ADDENDUM

ADD 03

Project Name:	Toronto Public Library: Pleasant View Library	ADD No.	03
Project Address:	575 Van Horne Ave North York, ON M2J 4S8	No Pages :	25 (Including Cover)
Project No.	22-008	Owner: :	TPL
Prepared By:	Duane Comins		
Date:	2025.05.21

A1.22

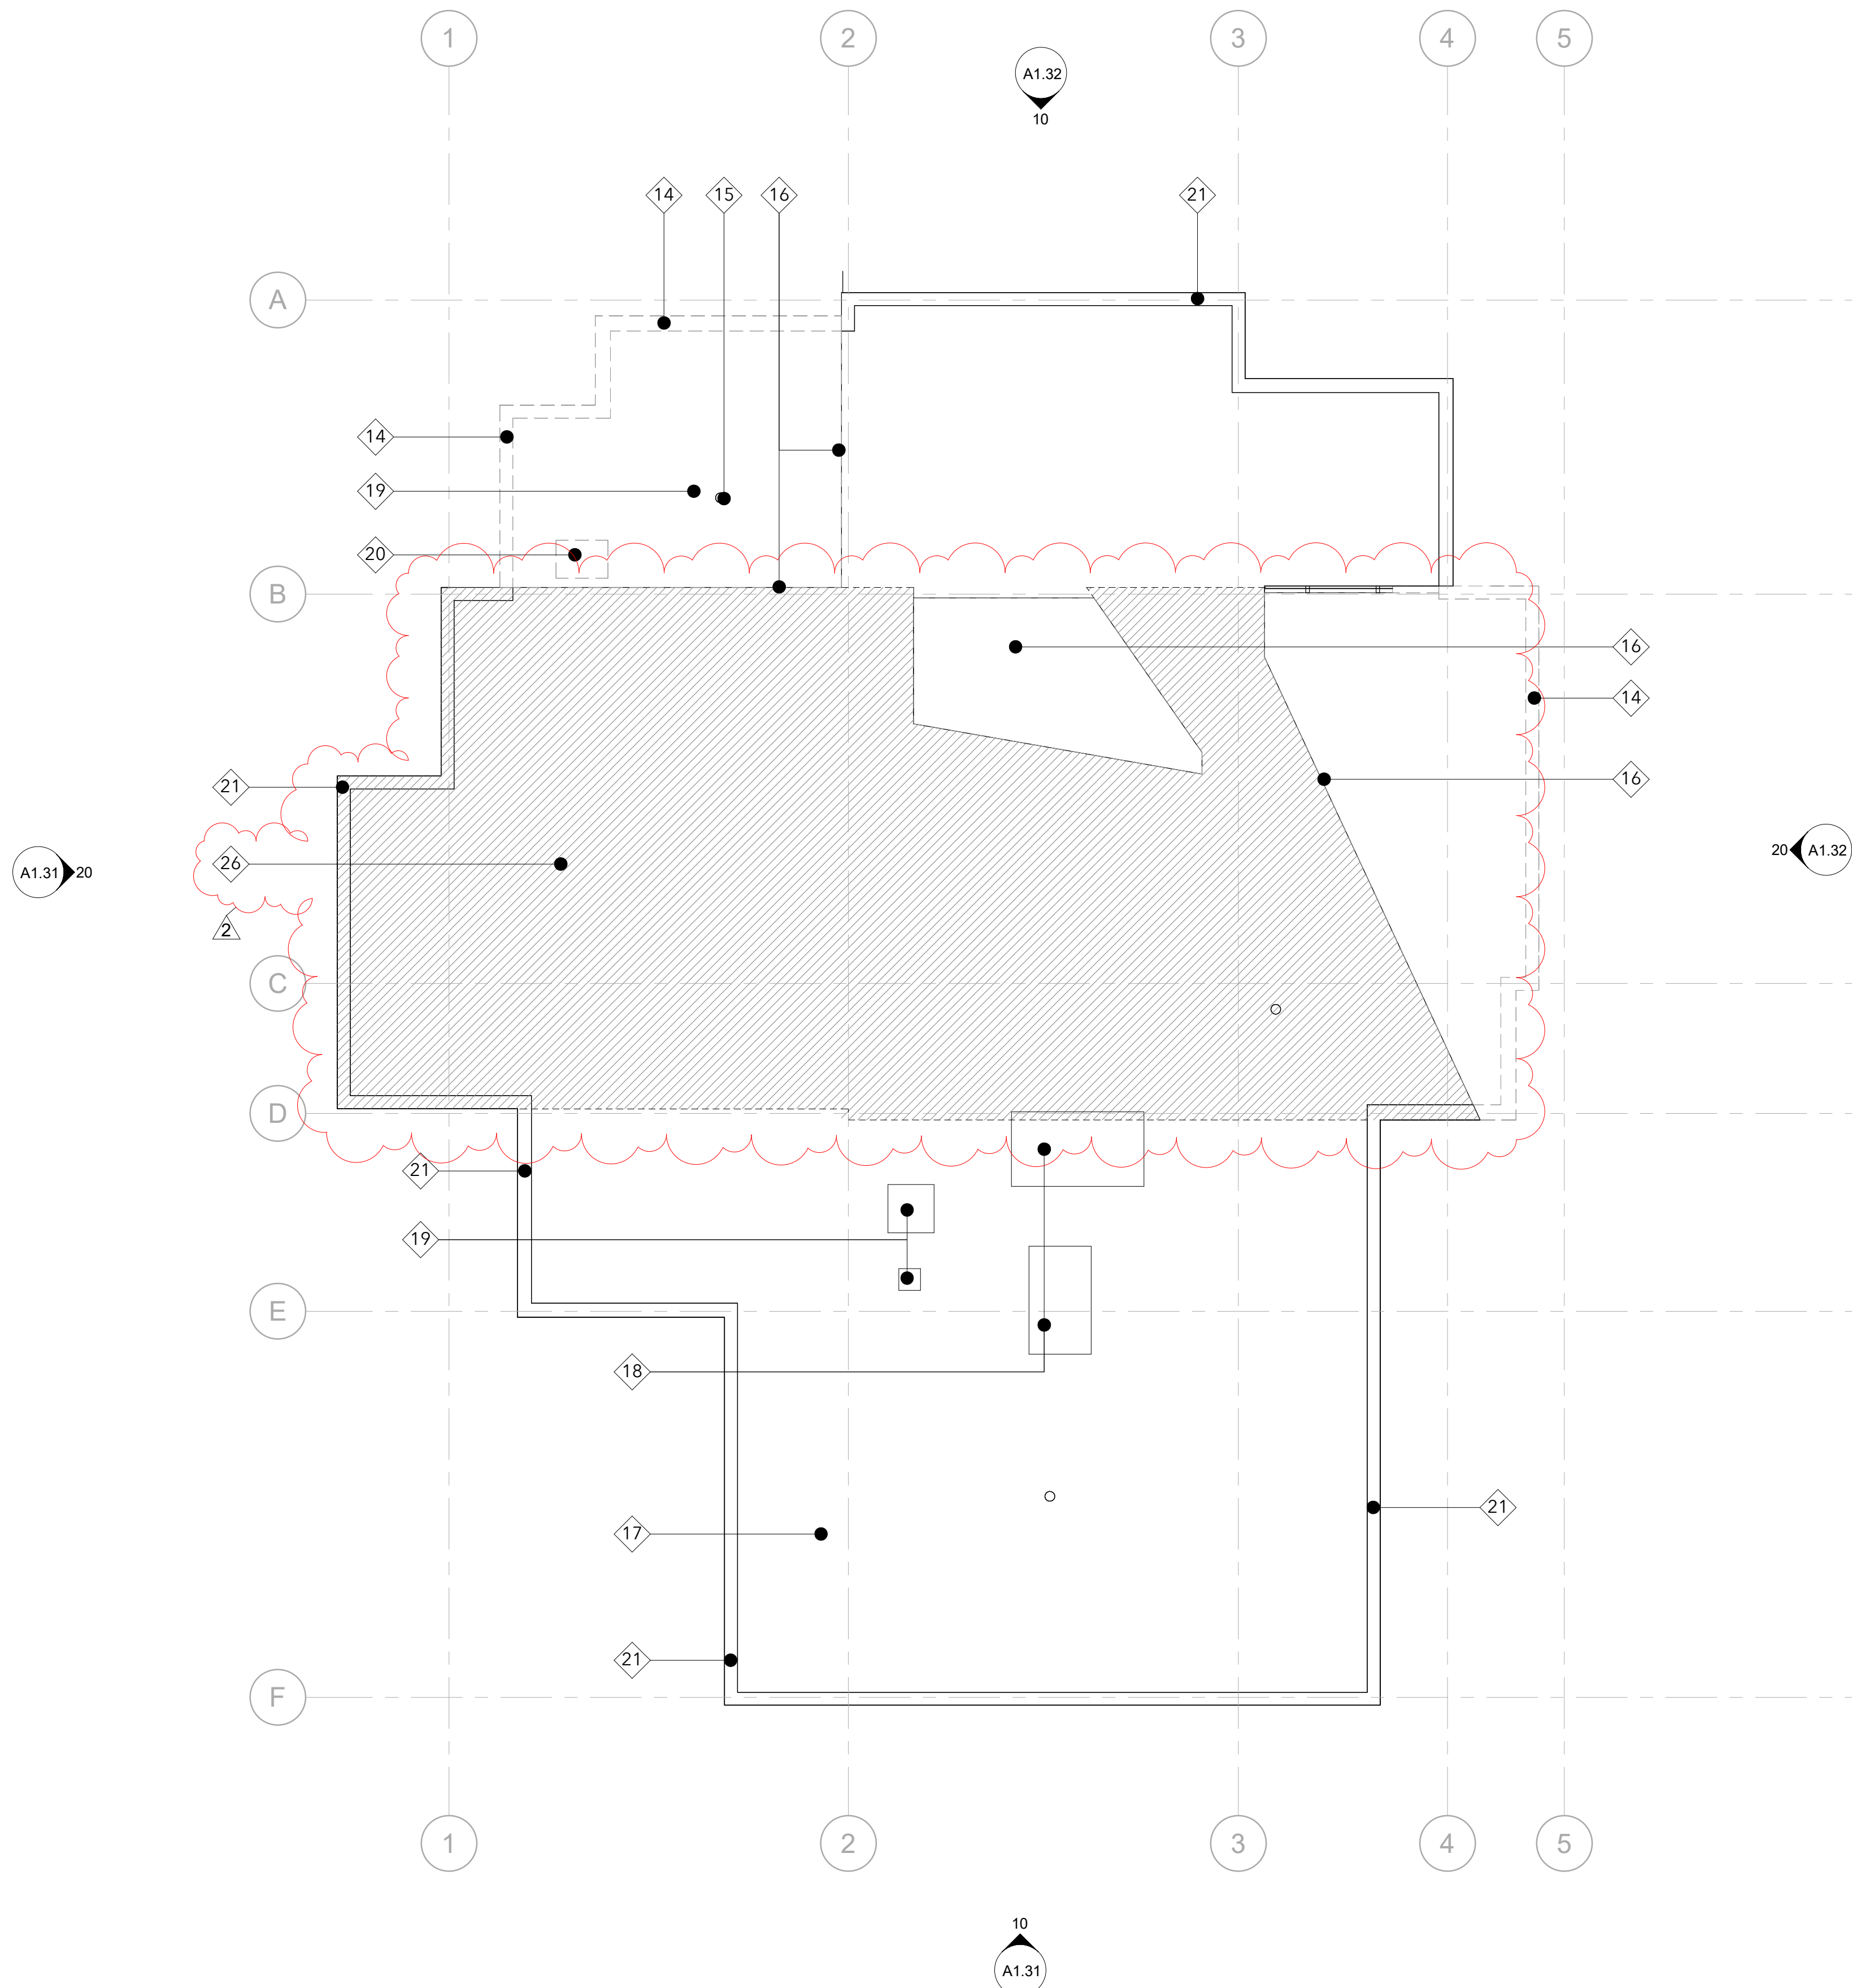
- 2.21 Question: Demolition Roof plan (A1.23) shows an area in which the existing roof system will be removed and then it has to be re-roofed as stated in note #26. However, the new roof plan (A2.12) says "Existing roofing membrane, roof structure, columns and foundation to remain. Please clarify if this area needs to be re-roofed or not. (see photo below hatched)**

Response: As noted in structural drawings, the structure is being reframed and we need new deck. Reference structural drawings for extent of work.

PLAN - ROOF LEVEL

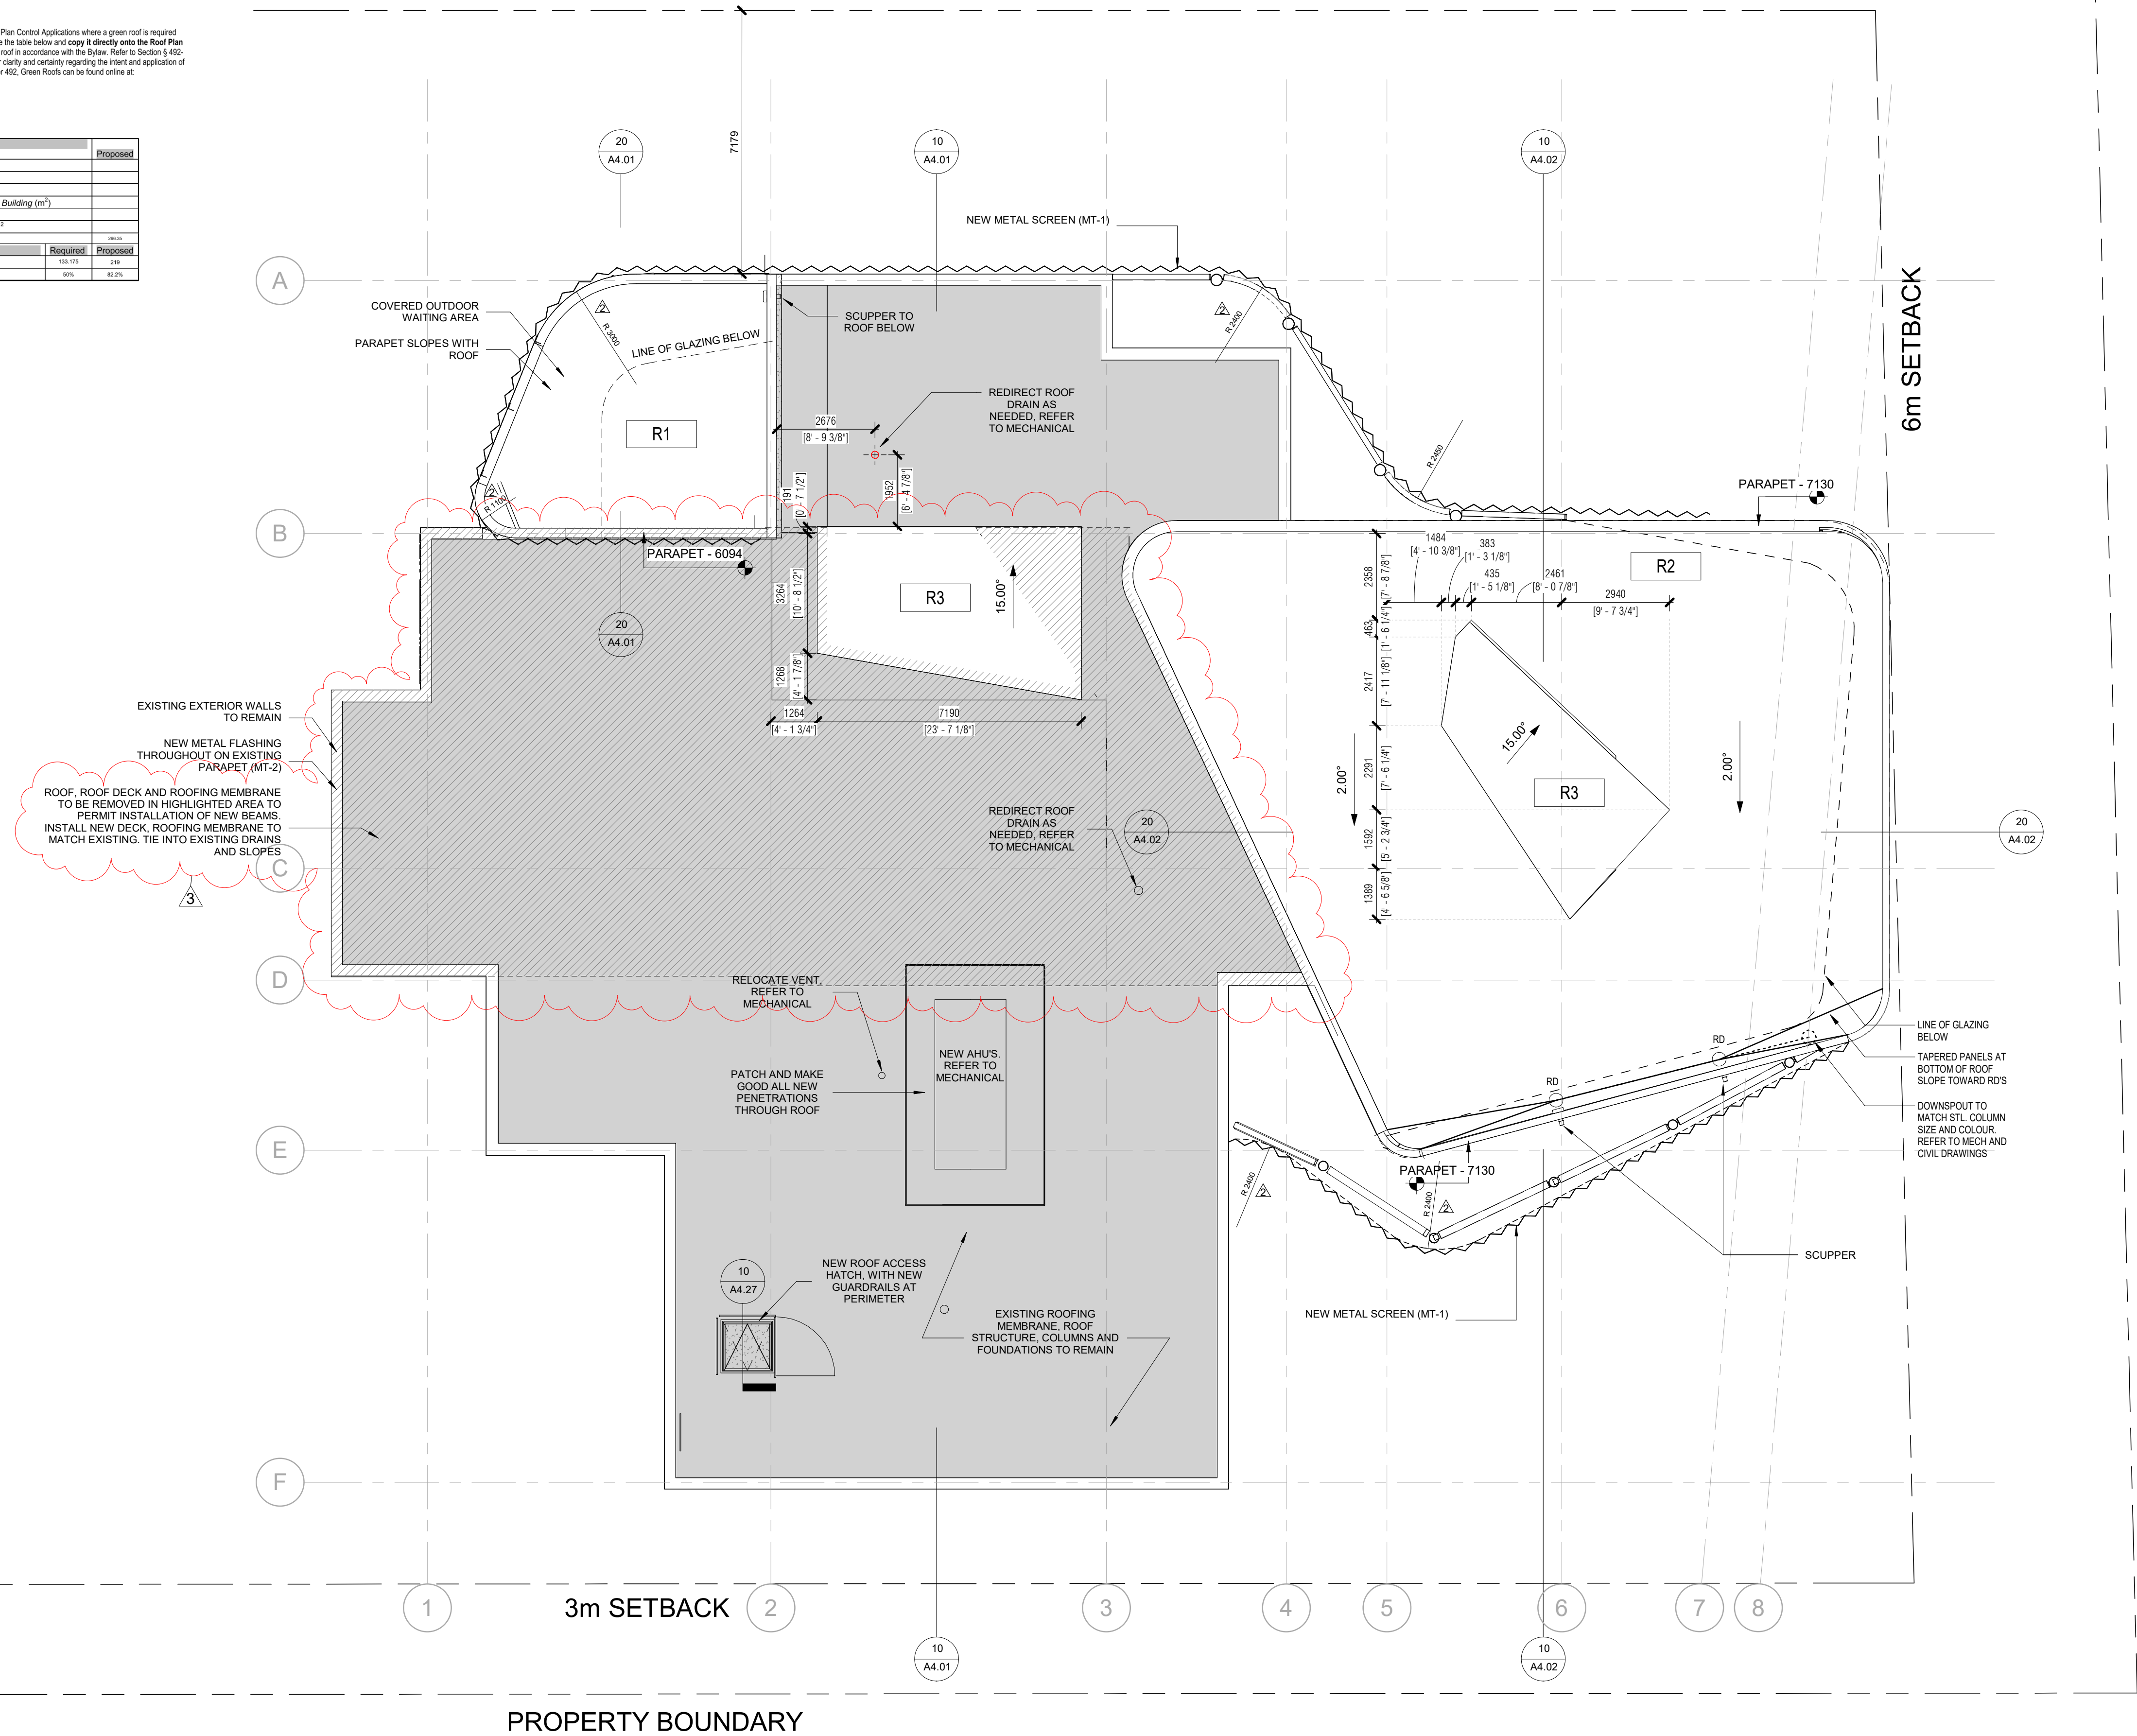
- 6.3 Question:** Structural drawing S2.02 indicates a new D1 roof steel deck (38x0.76), while roof drawing A2.12 shows the existing roof, which suggests reusing the existing deck. Could you please clarify this discrepancy? To install the new D1 deck as shown, we would need to demolish the existing roofing and the underlying deck. Please see the attached snippet highlighting the area in question with the proposed new D1 deck.

Response: As noted in structural drawings, the structure is being reframed and we need new deck. Reference structural drawings for extent of work.

RCP DIMENSIONS -
LEVEL 01

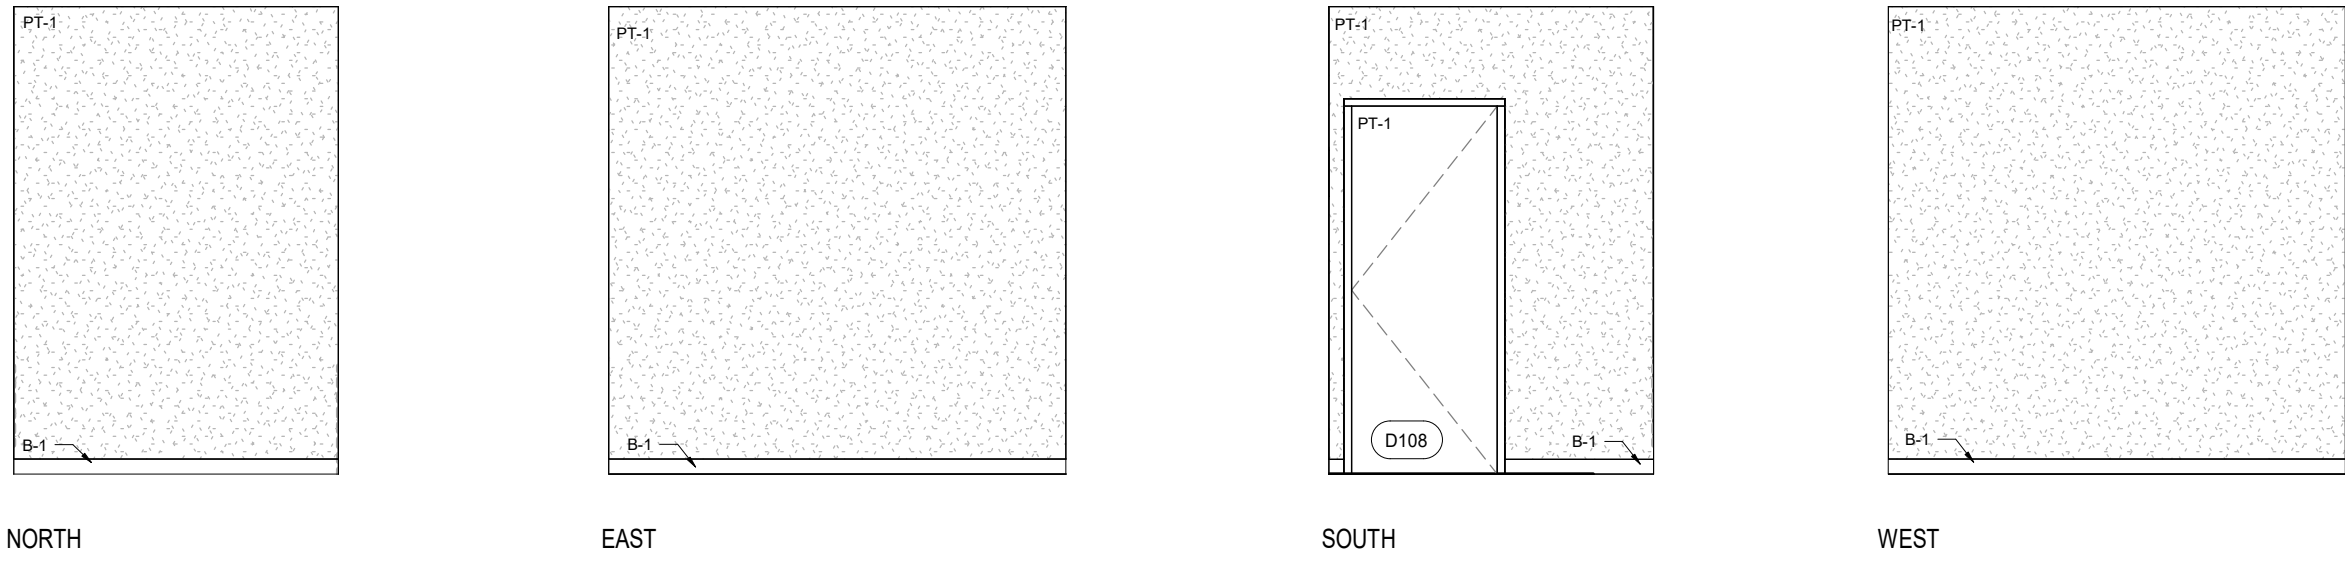
- 2.3 Question: After sending the drawings to Armstrong for C-4 Lyra clouds, they let us know that the radius on most of the corners in the clouds are too small/tight for them to manufacture. Therefore, we are unable to include the trims for C4 on the quote. If an addendum comes out providing changes or clarification, please let us know and we will try our best to provide a quote.**

- 2.8 Question: Drawing A8.01, A8.02: The wood baffles heights are noted as 475mm and 310mm but also indicating "varies - refer to RCP" Please advise the intended height and thickness of the wood ceiling baffles as this information is not clearly identified on the RCP.**

Response: Please see attached revised A2.32, smallest radius is 18". Please use the Armstrong Axiom.

Response: As noted on A2.32 RCP Dimensions, the underside of the wood baffles will be sloped, therefore the height of the baffle will vary depending on the location at which the section is cut. Height of wood baffles range in location from 225MM to 550MM. Please see attached A2.32 for some key baffle heights, it is expected the GC will take these points in order to create the sloped baffles.

STAFF AREA ENTRY

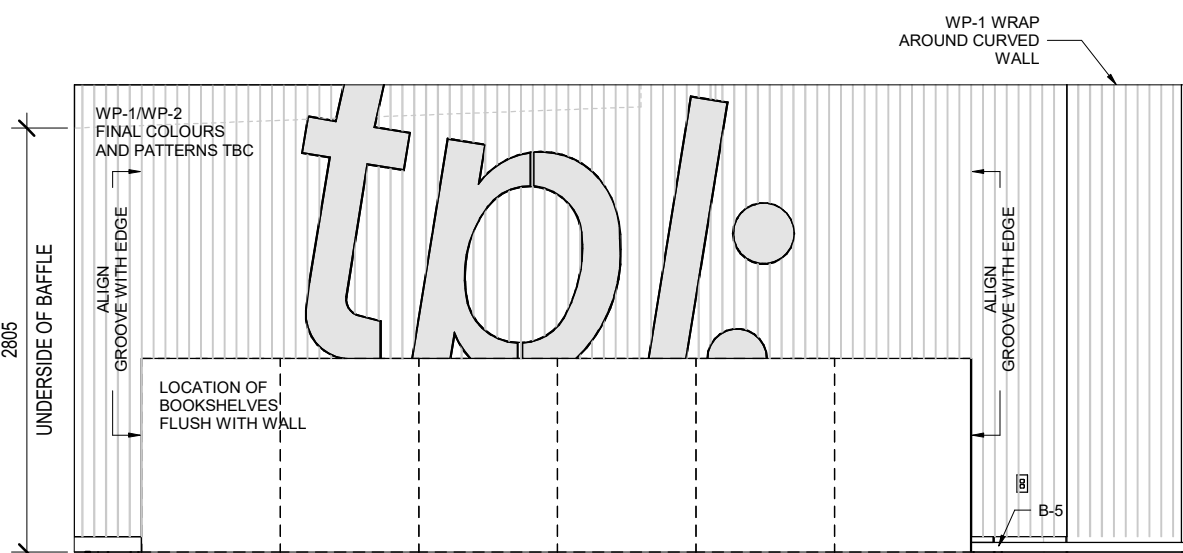
2.31 Question: Drawing A2.42 Stuff entrance PT-1 / WP-1. However, elevations for the same # 13 A6.03 calling PT-5 without wall panels. Please confirm.

Response: Reference Question 7 in posted Addendum 02 (May 13, 2025) - Revised A6.03 attached previously
